# H8-Z5-5 Board Rework
Fix 16550 RS-232 Handshaking Polarity

Only for boards Rev 1.0, 1.1, 1.2. & 1.3.

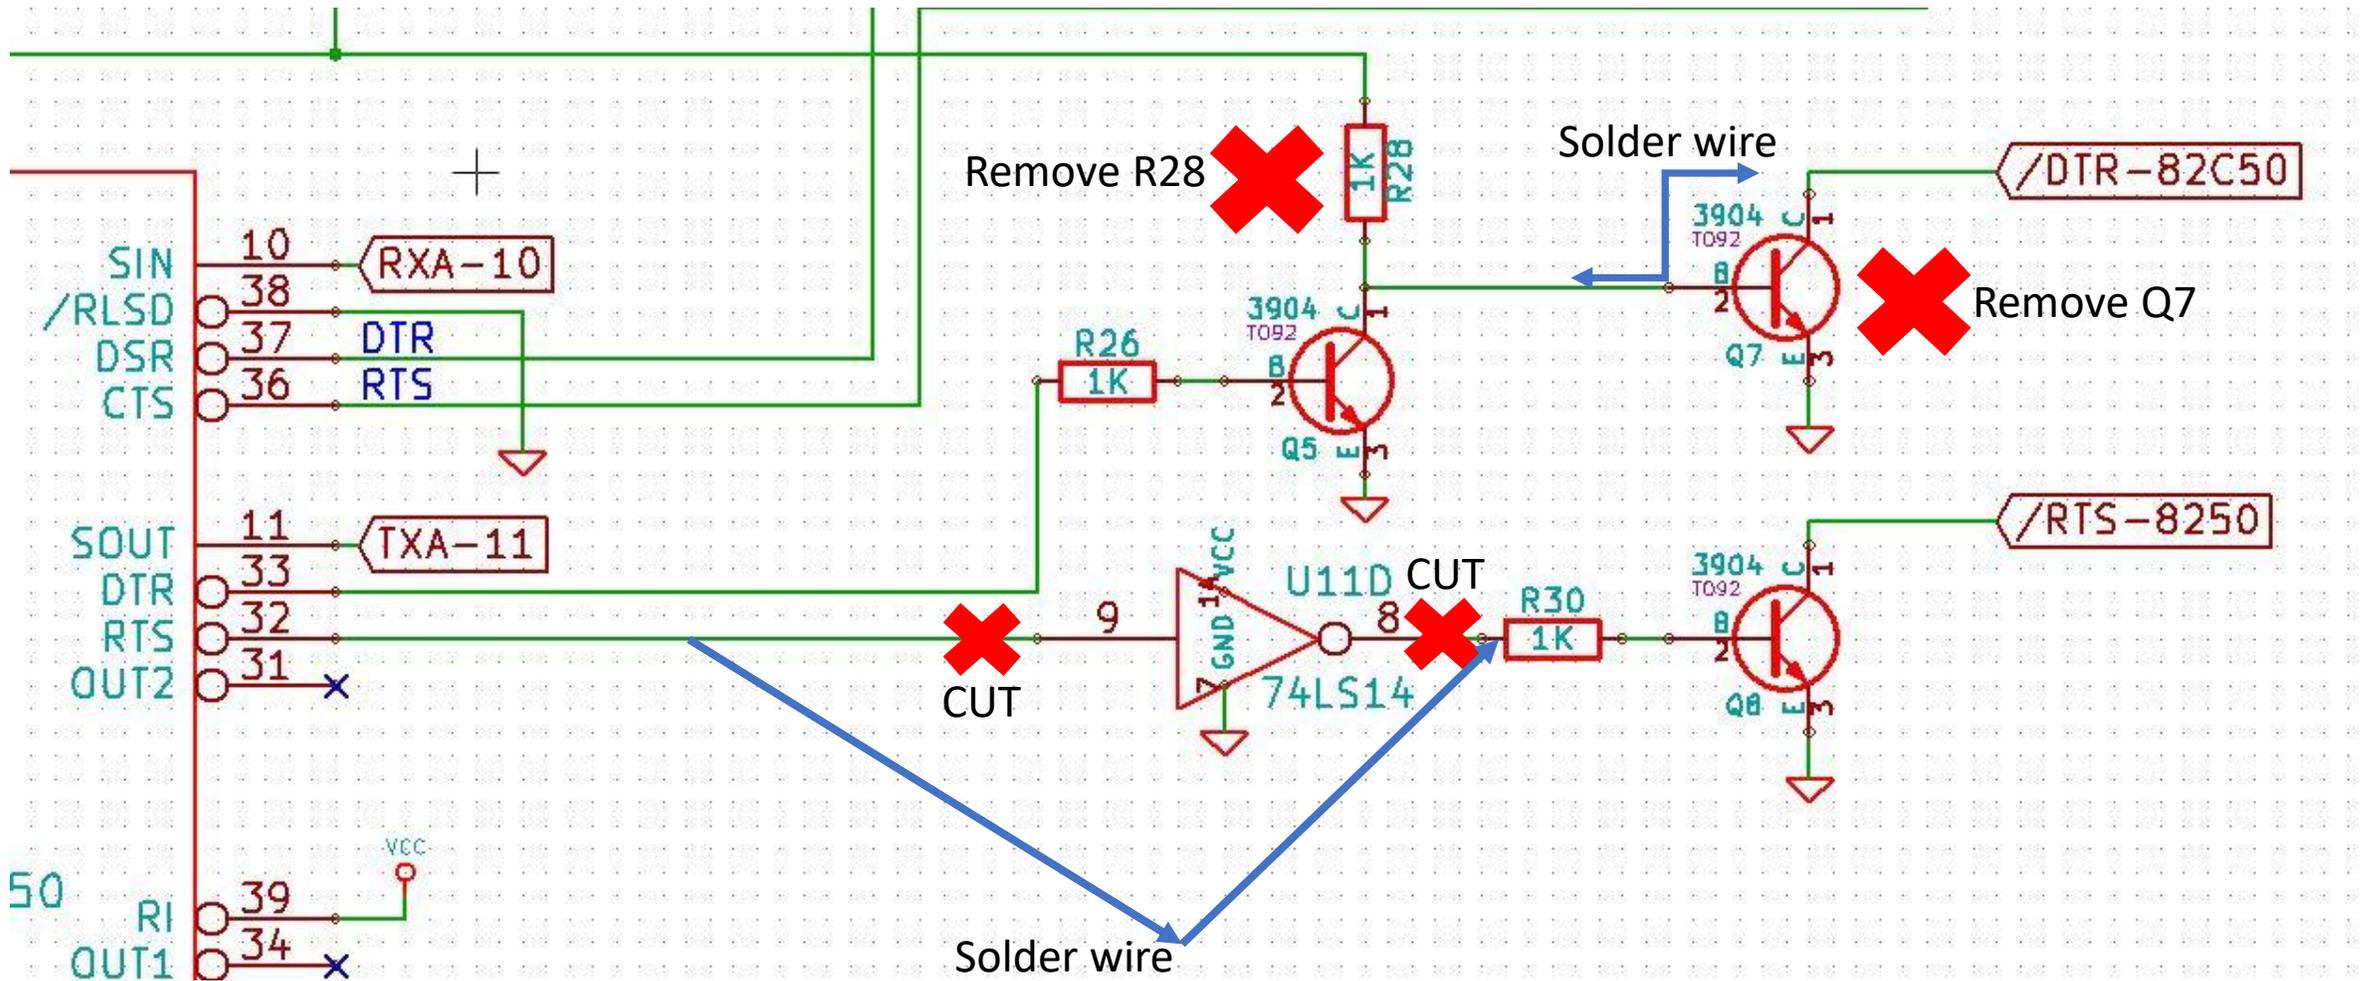
1.0 Cut traces on side 2 of U11 (74LS14) on pins 8 and 9 as shown.

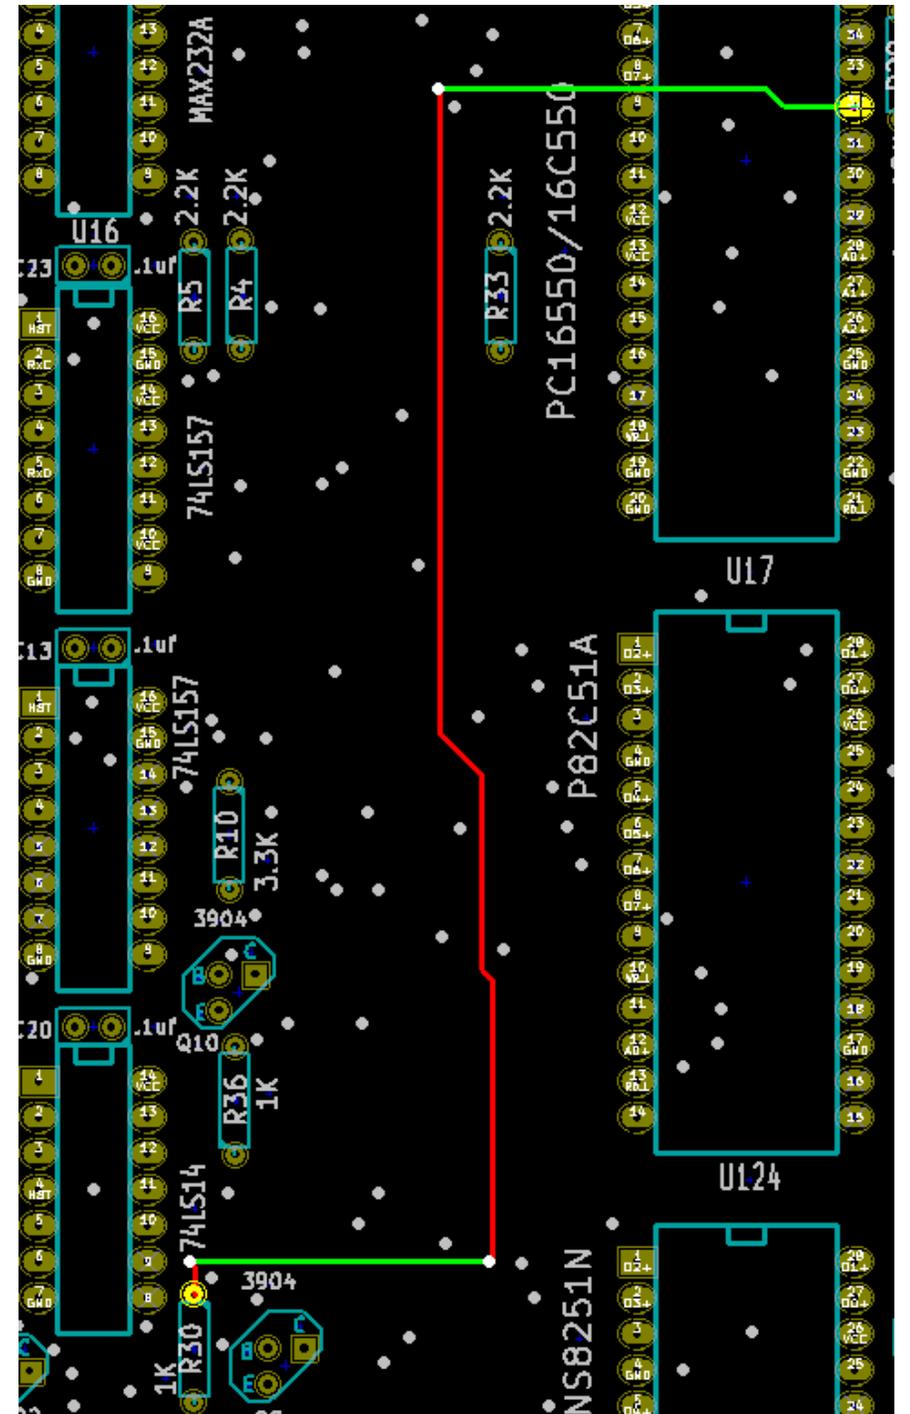
1.1 Remove the following Components:

- ☐ Q7 – 3904
- ☐ R28 – 1K

1.3 Solder wire between Q7 pin 1 (C) and pin 2 (B)
1.4 Solder wire between Pin 32 (U17) and resistor R30 pin 1.
